# mk1 C920 PCBA wiring

## New C920 wiring

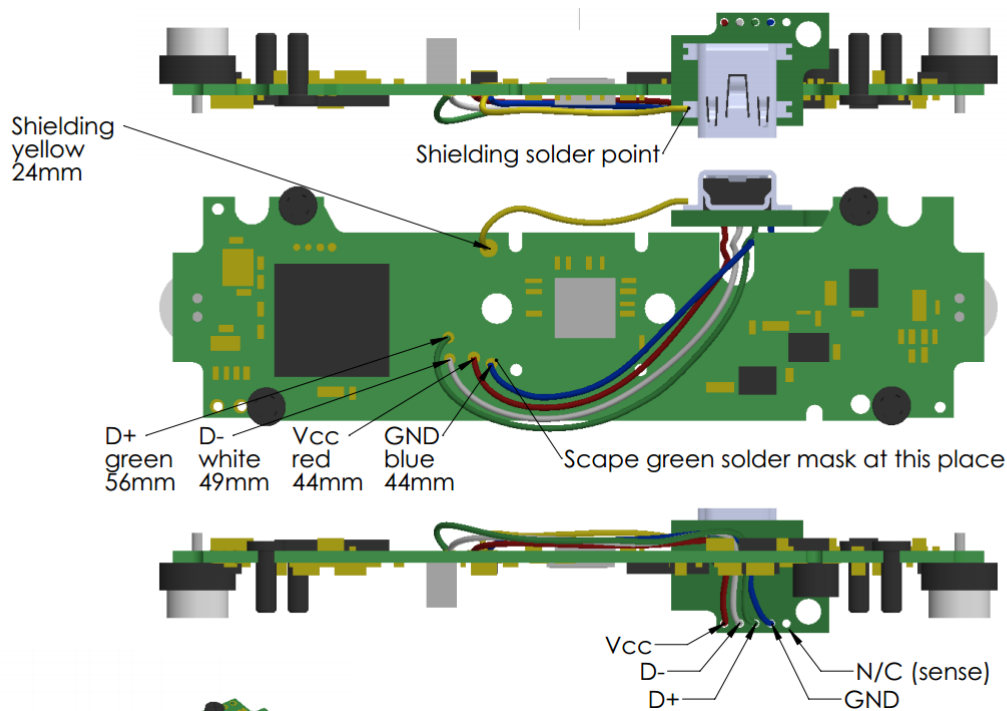
Recently updated C920 webcam version was released featuring new PCB. These changes introduced two unexpected issues: wiring is different and new PCB has mechanical interference with aluminium rework kit back plate.

Interesting note - looks like new PCB release was rushed, spot mirrored J2 designator.

If you rework webcam by yourself, please use pin-out diagram as pictured below to solder wires.

Test point	Signal
TP24	VCC
TP26	USB D+
TP25	USB D-

TP27

GND

## Old C920 wiring

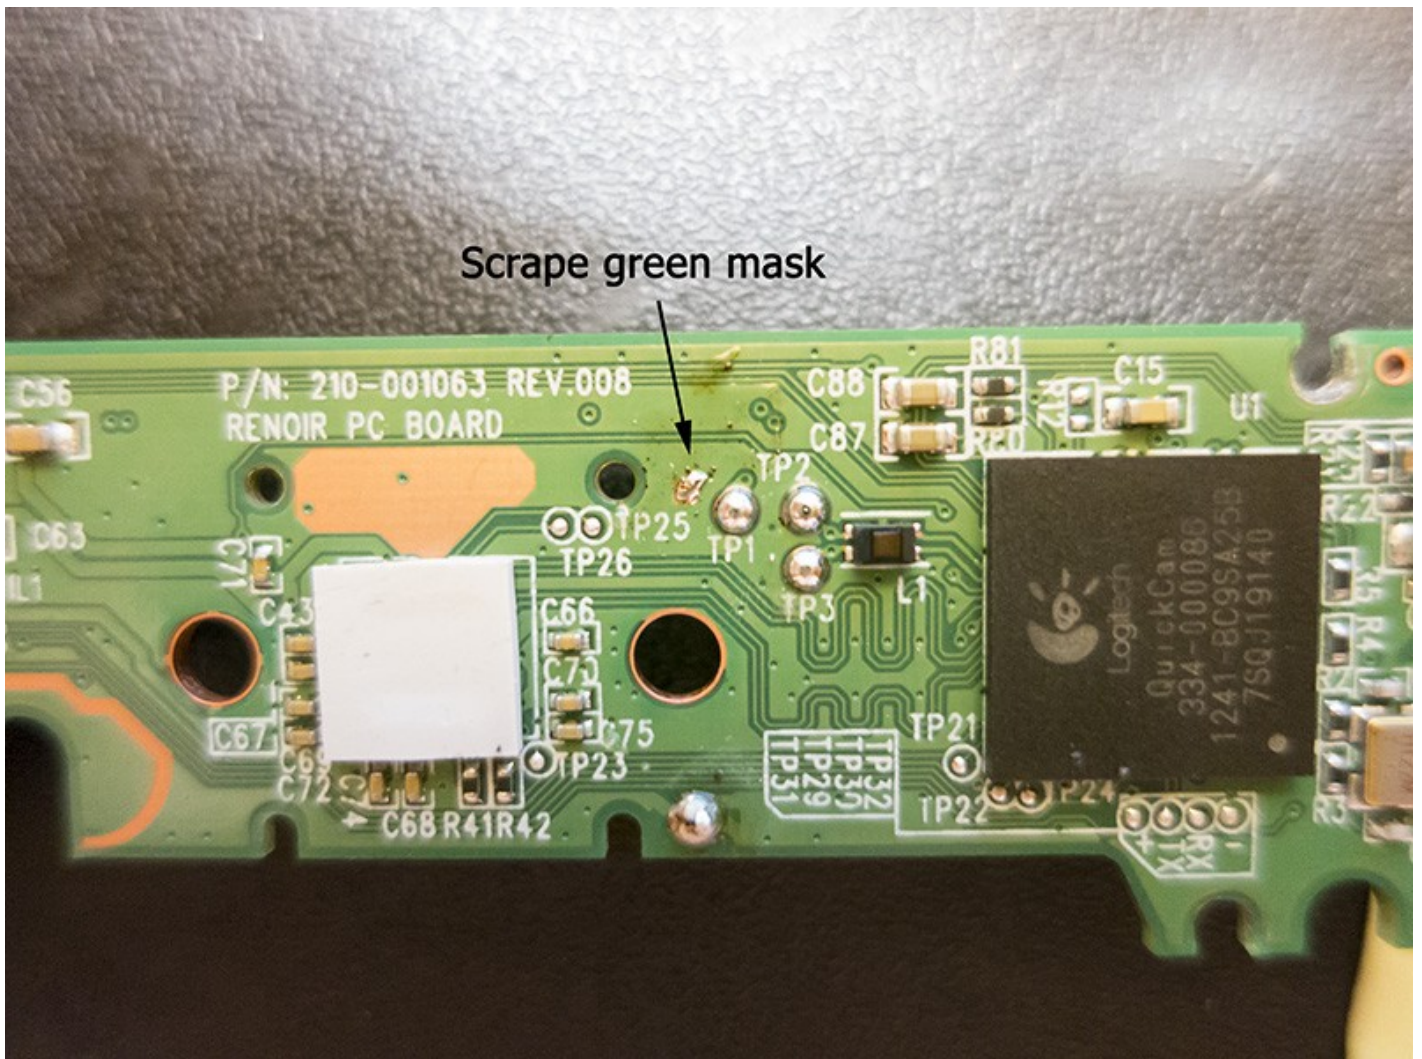
Route USB wires as indicated in this diagram. I found Kynar monolithic wires are the best – small and easy to solder. 5 wires will be used USB D+, D-, GND, Power. Shield also has to be soldered.

USB connector is available on the other side of PCB and it is surface mount type. Therefore it will be easier to use test pins. While GND is not available as test pin I recommend making pad by yourself. You can also use other places to solder GND wire, it is just my recommendation. Scrape

green soldering mask with scalpel to access GND.
